[Phase 4] ESW490-42 – IXYS Brand Schottky Diode Discrete Alternative Qual Status

Product/Process Change Notice (PCN)

PCN#: ESW490-42 **Date:** Dec 17th , 2024

IXYS Brand Schottky Diode Discrete Alternative
Qual Status

SOT-227B package Schottky

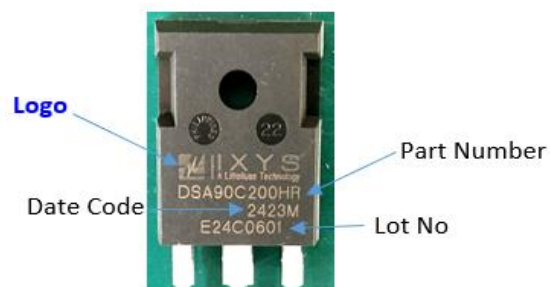
For SOT-227B and ISO-247 package Schottky: Below is the detailed change information.

Item		Existing	New
Unit Marking	Logo		
Box Label	RoHS Label	 e1	 e3
Box Label	Logo		
	Lot No	No	Yes
	Code Type	Barcode	Barcode + 2D Code
Tube Label	Logo		
	Lot No	No	Yes
	Code Type	Barcode	Barcode + 2D Code

Tube Label:

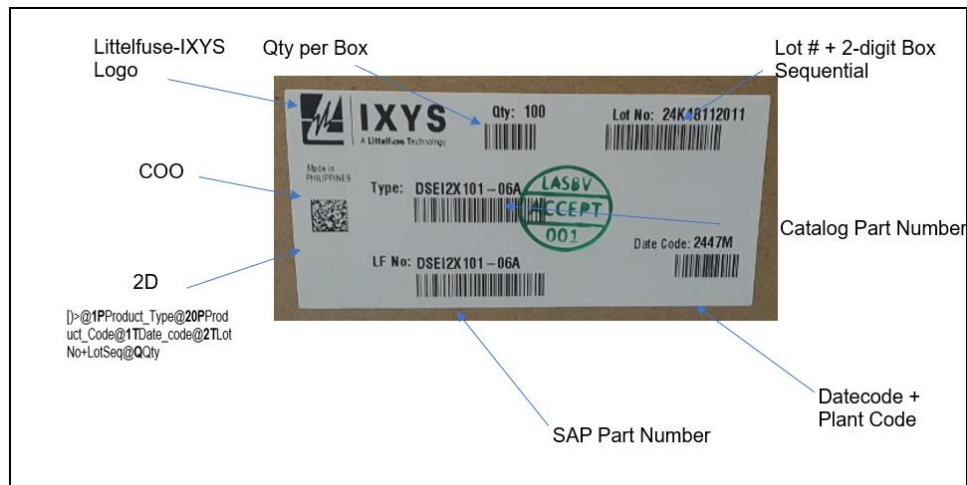
Note: Sample Label using SOT-227 Package

Conclusion: Actual marking confirms with marking set up at Datasheet.
For Tube and Box labels, no significant impact on the application.
